GOVERNMENT OF MADRAS.
PUBLIC WORKS DEPARTMENT.

ORDER—dated 26th September 1895, No. 2381 W., Public Works.

The design applied for by the Superintending Engineer is now obsolete and a revised design recently prepared is circulated for adoption.

REVISED TYPE DESIGN FOR A DEPUTY TAHSILDARS OFFICE-TILED ROOFING.

PLINTH AREA (EXCLUSIVE OF COURT-YARD AND STEPS) = 5567 SQ. FEET.

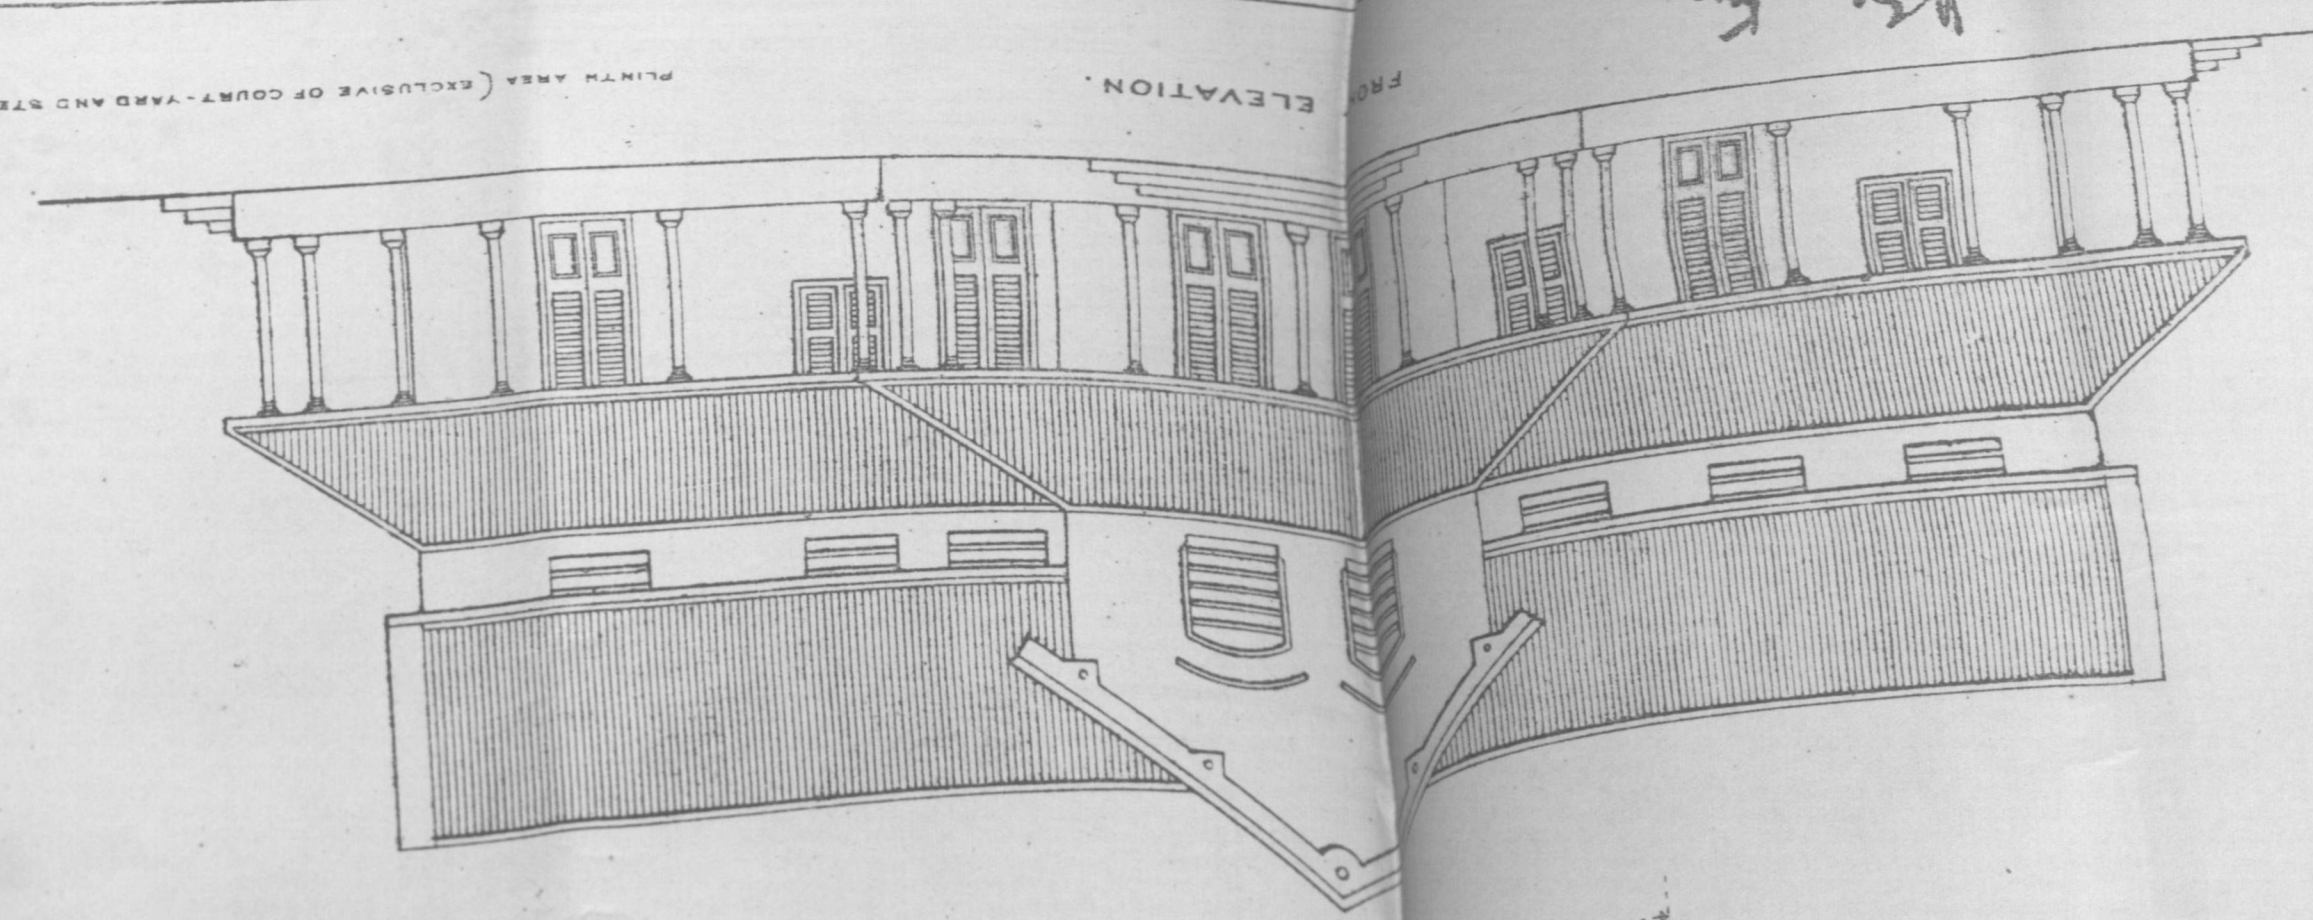
The revised design pro-
vides for the elongation
of the side verandah to the
police guard & altering
the position of steps at
sides, also it now shows
the elevation of the record room
the side elevation & the
position of fences on ground
plan.

NOTE. THE FOUNDATIONS AS SHOWN SHOULD NOT BE TAKEN AS A GUIDE. IT WOULD BETTER TO CONSTRUCT THEM OF CONCRETE TO GROUND LEVEL. THE CONCRETE TO BE 2 FEET, ONE FOOT ON EACH SIDE BROADER THAN THE MASONRY IMMEDIATELY ABOVE, AS SHOWN IN THE SKETCH. FOR EXAMPLE.
